SECTION 131 FORM

ABP— 314485-22

Planning Appeal Online Observation

Dublin Airport, Co Dublin

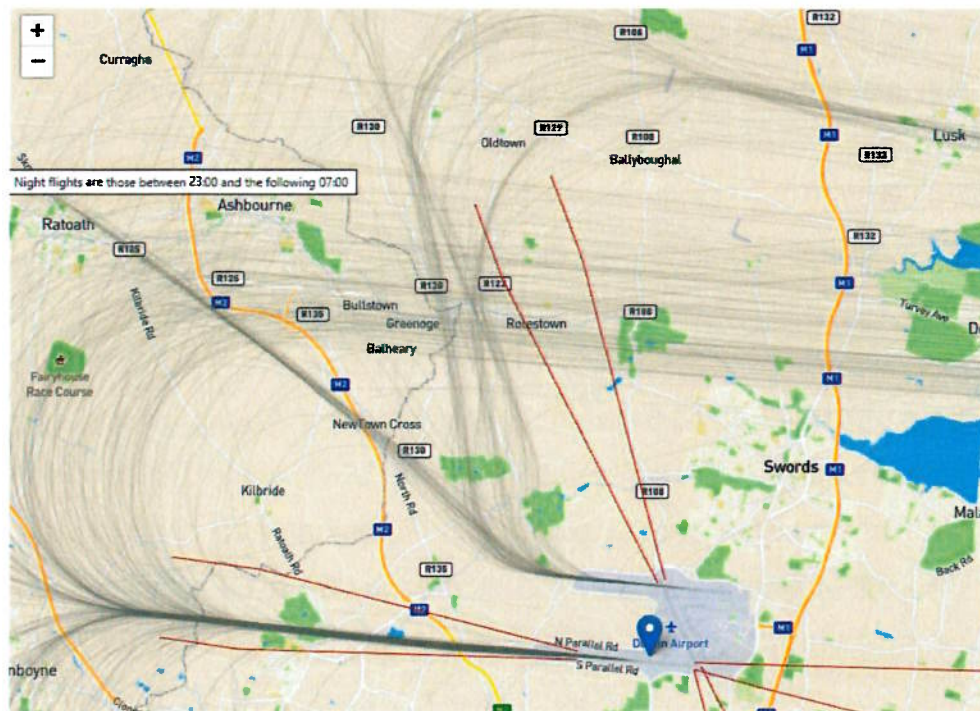
- Flying divergent flight paths on the North Runway for Westerly operations contravening the EIS of 2007
- Divergent flight paths currently in operation do not align with EIAR for this current planning application that is under appeal

- 30-degree divergence was not proposed in the 2016 consultation
- Condition 3 of planning does not allow for dual runway departures under Option 7b
- Flight paths used in Insulation Scheme approved by Fingal County Council in 2016, based on 2007 planning permission, show straight out operations

- Departures on North Runway on August 25-27th and all dates of westerly departures since opening are showing divergent routes contravening the planning permission from 2007
